08-018 Rev A  
12 November 2008

**SW0000026 TO SW0000059 SUBSTITUTE PART (Information Note)**

This is an informative service note that shows the difference between the SW0000026 pressure sensor and the SW0000059 pressure sensor.

**SW0000059**

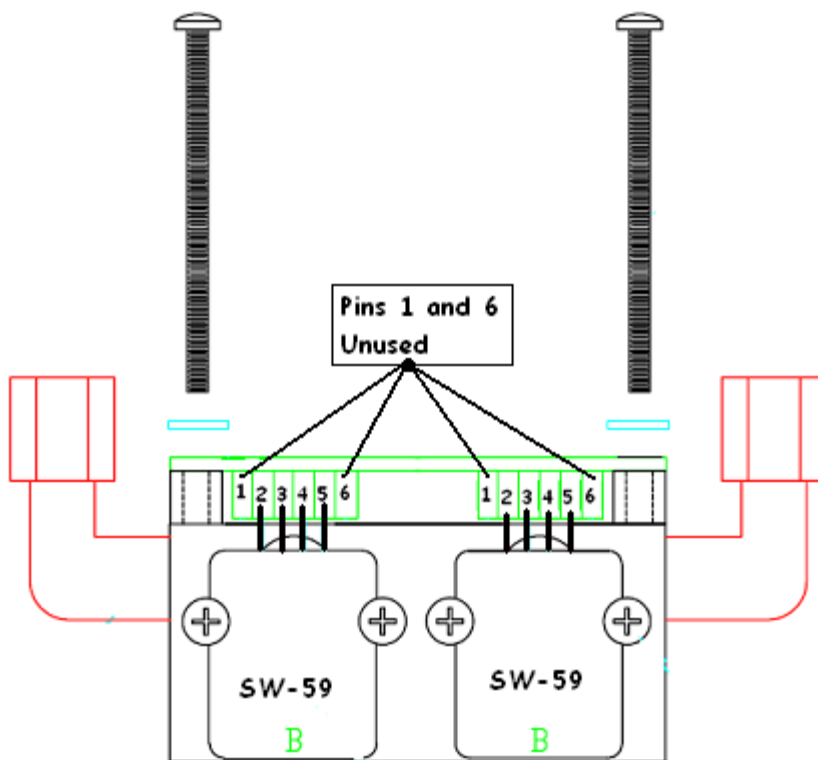
1. The SW0000026 pressure sensor is now obsolete and we are using SW0000059 in its place. The big difference between the two parts is that the SW-26 had 6 pins and the SW-59 only has 4 pins, their functionality is the same. The new SW-59 with 4 pins will be installed with the two outer pin sockets being unused. So sockets 1 and 6 will not have anything in them with the SW-59 going into 2,3,4 and 5. Please see the attached diagrams for further information.
